BIGGS & MATHEWS ENVIRONMENTAL

June 27, 2014

Re: 130 Environmental Park – Caldwell County
Municipal Solid Waste (MSW) – Permit No. 2383
Response to Second NOD for Land Use Compatibility Determination and
Submittal of Complete Parts I, II, III, and IV Permit Application
Tracking No. 17458939 (17937410, 17978232, 17992596, 18005911);
CN604375972/RN106897036

FIGURE
IIA.9A

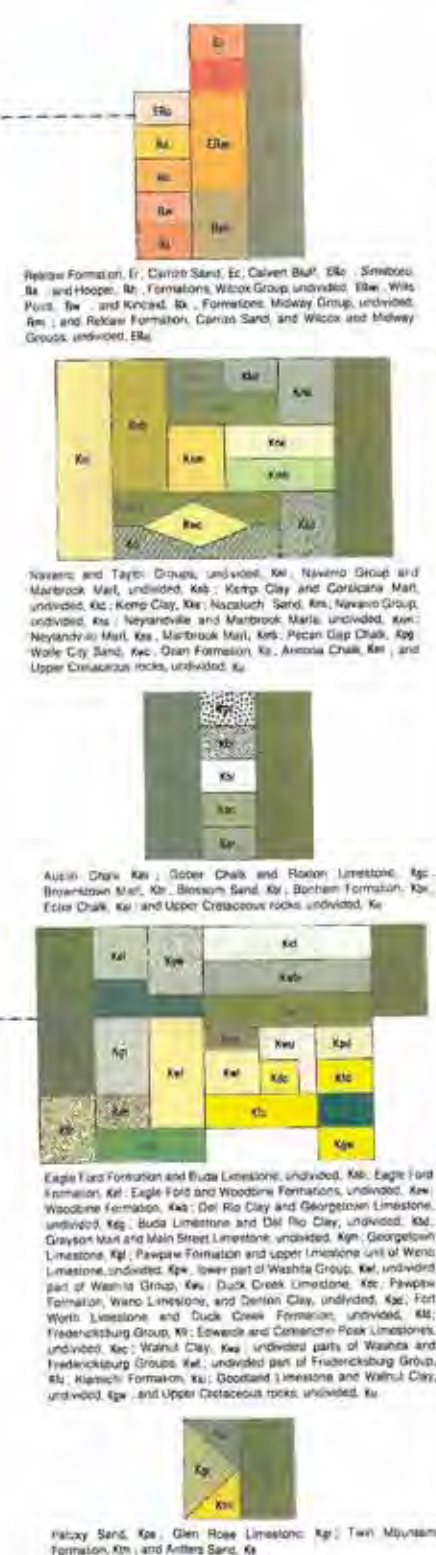
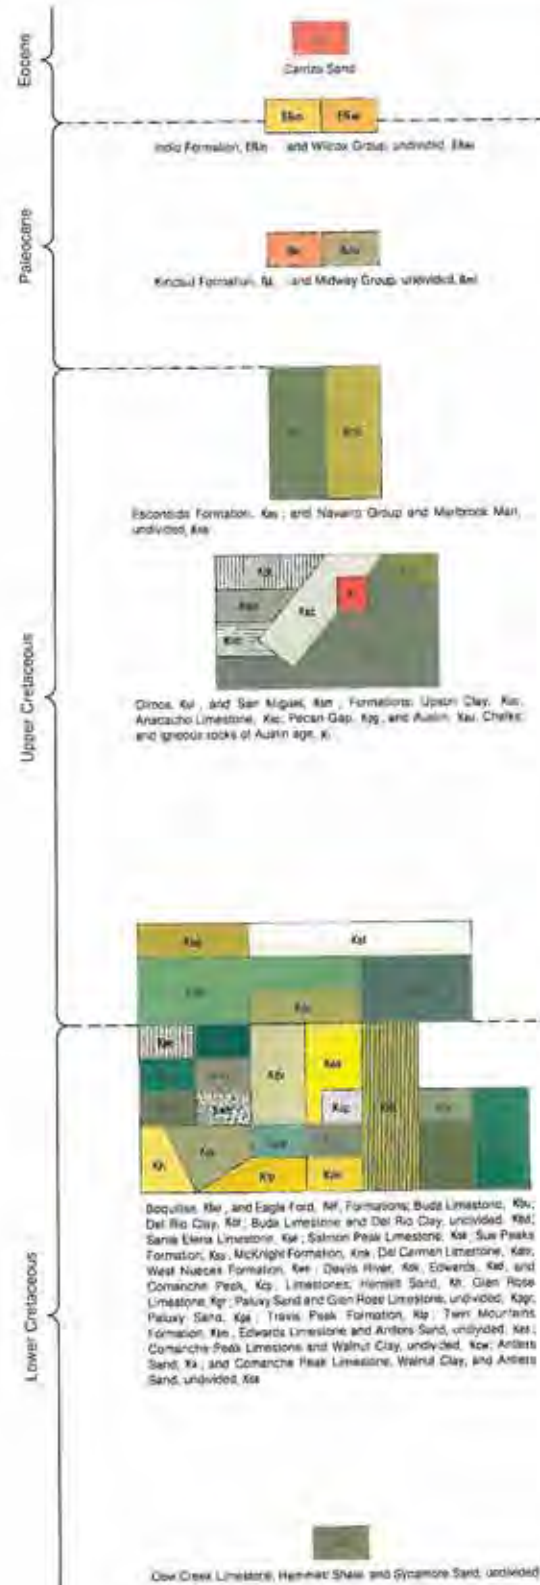
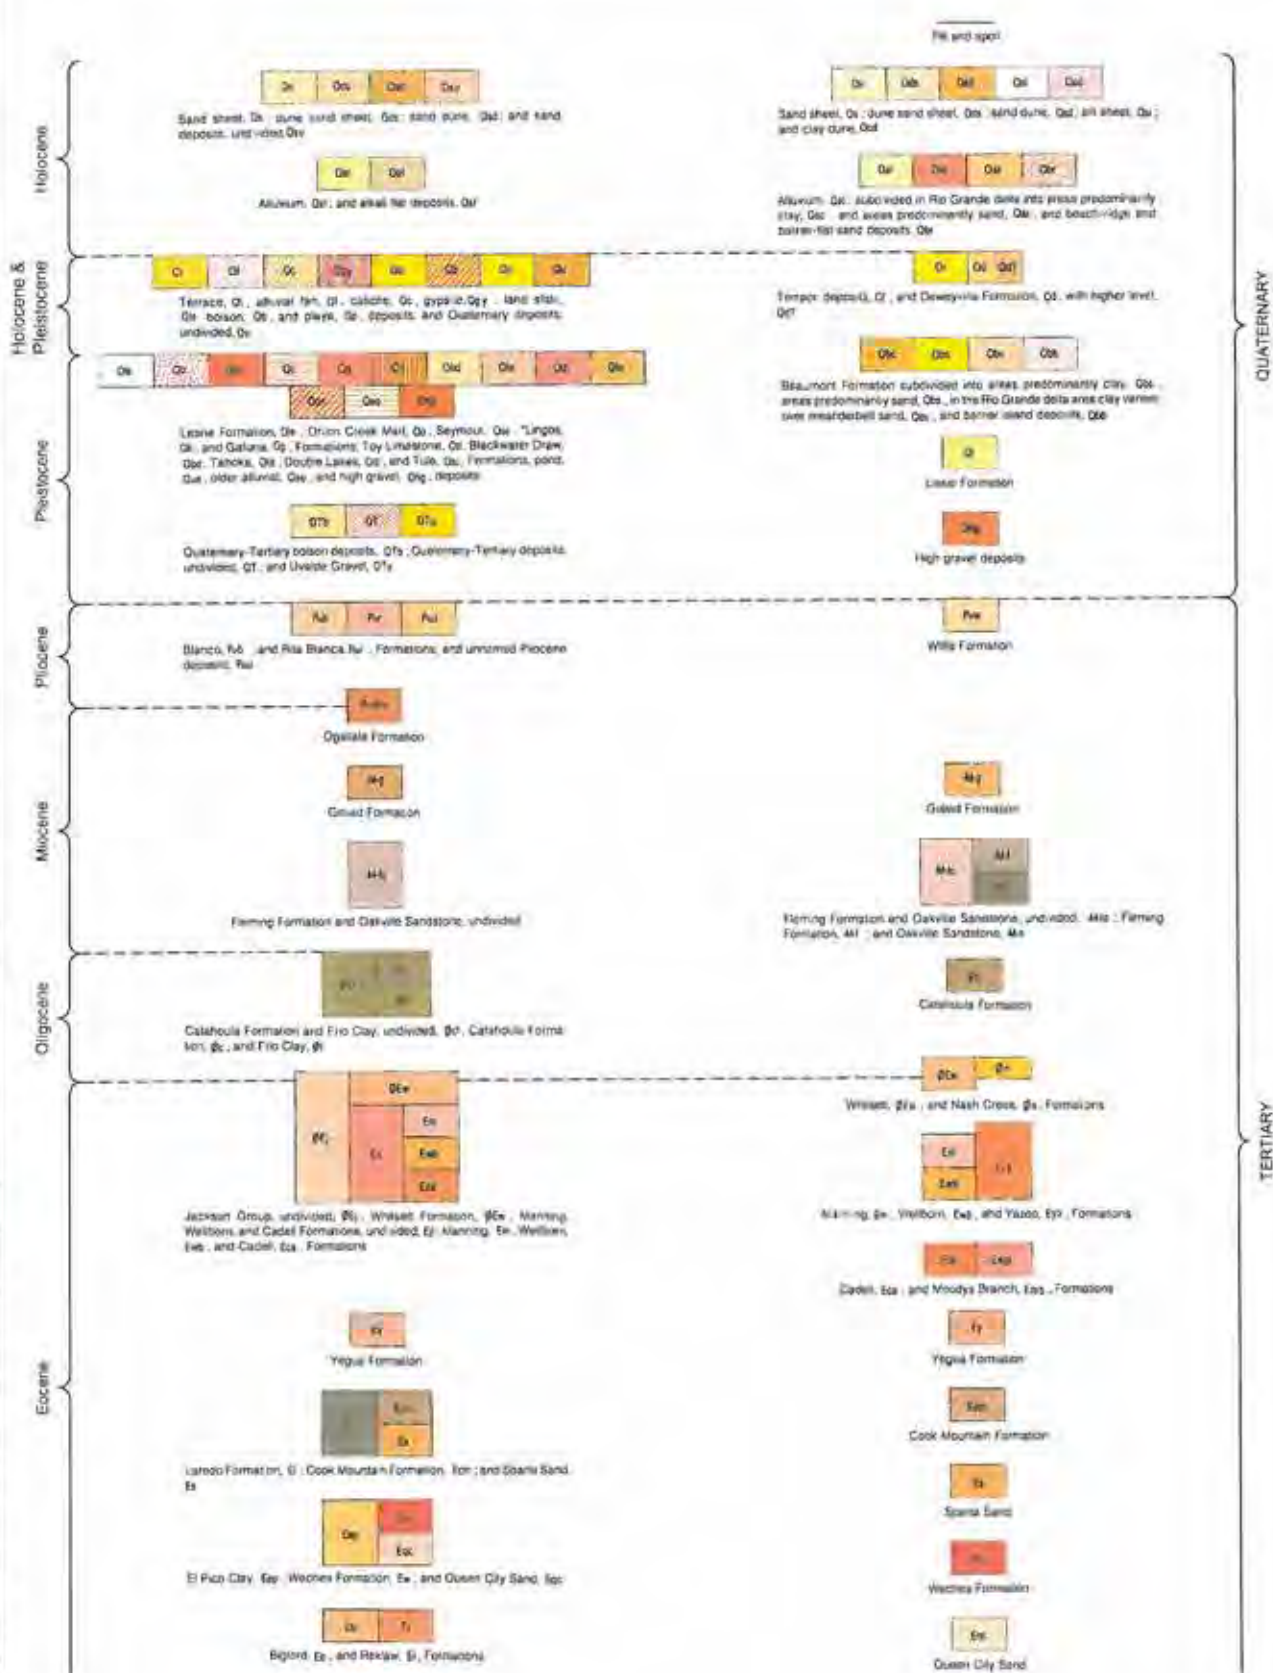
10. In our technical review letter dated November 25, 2013, regarding the initial application for a land-use only determination, we requested a larger scale geologic map in the area of the proposed landfill to show clearly the locations of mapped faults and their proximity to the landfill. The response included a replacement of Drawing IIA.9, Geologic Vicinity Map, from different sources, but at approximately the same scale as the map in the initial application. Please provide a larger scale map (an

enlargement) in the area of the landfill, extending to a sufficient distance from the proposed facility boundary to show any faults within the distances noted in 30 TAC §330.555.

RESPONSE: *As requested, a larger scale map has been included. For clarity, the proposed permit boundary and footprint have been included on the figure.*

REVISIONS						TBPB FIRM NO. 1-256		TBPB FIRM NO. 50222	
1	06/14	N.O.D. NO. 1 RESPONSE	SRC	JMS	JMS	DSN, JMS	DATE : 06/13	DWN, GLW	DRAWING
REV	DATE	DESCRIPTION	DWN BY	DES BY	CHK BY	CHK	SCALE : GRAPHIC	DWG : IIA.10-SeisImp.dwg	IIA.10

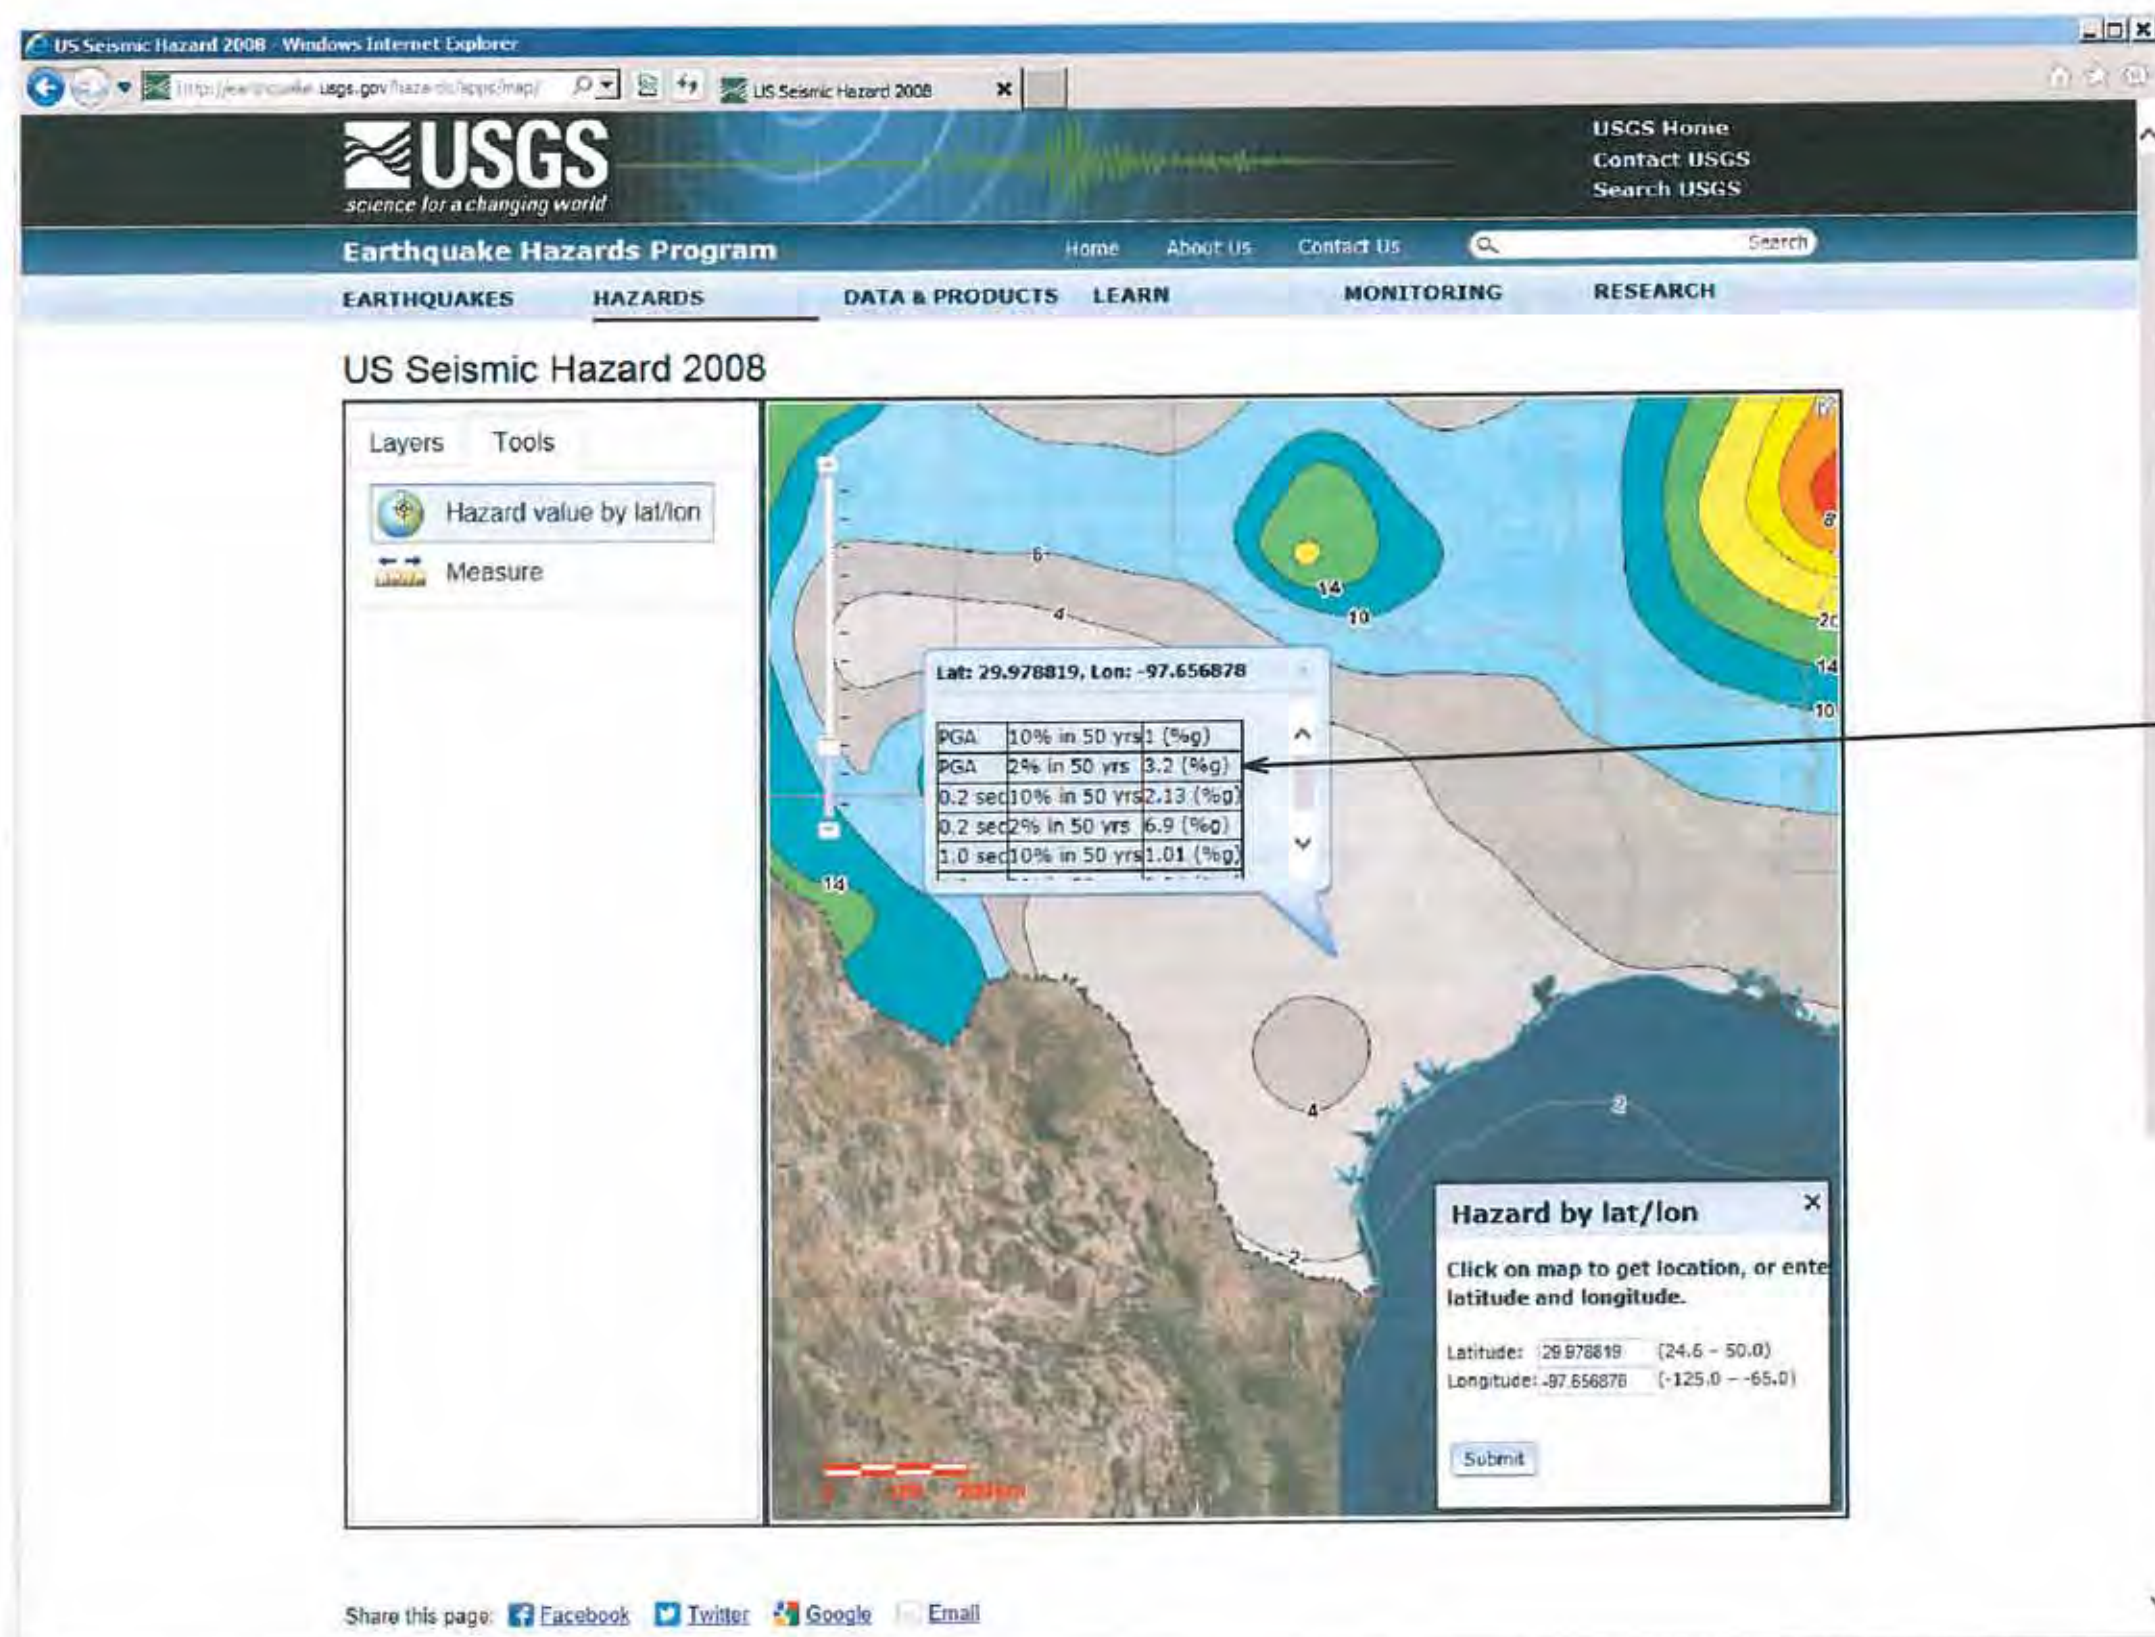
11. Please address the following comments regarding Drawing IIA.10, Seismic Impact Zone:

- a. We were unable to locate the source of information for the map using the URL reported on the drawing. Please provide more information about the source of the map.

- b. Revise the legend to indicate that the drawing shows contours of peak ground acceleration in units of percent of gravity (% g). Please also delete the note beneath the legend, or revise the note for accuracy.

RESPONSE: *The Seismic Impact Zone maps (Drawings IIA.10 and E4.1) have been revised per recent discussions with TCEQ, the screen-shot map, note and source have been changed.*

RESPONSE: *The Seismic Impact Zone maps (Drawings IIA.10 and E4.1) have been revised per recent discussions with TCEQ, the screen-shot map, note and source have been changed.*
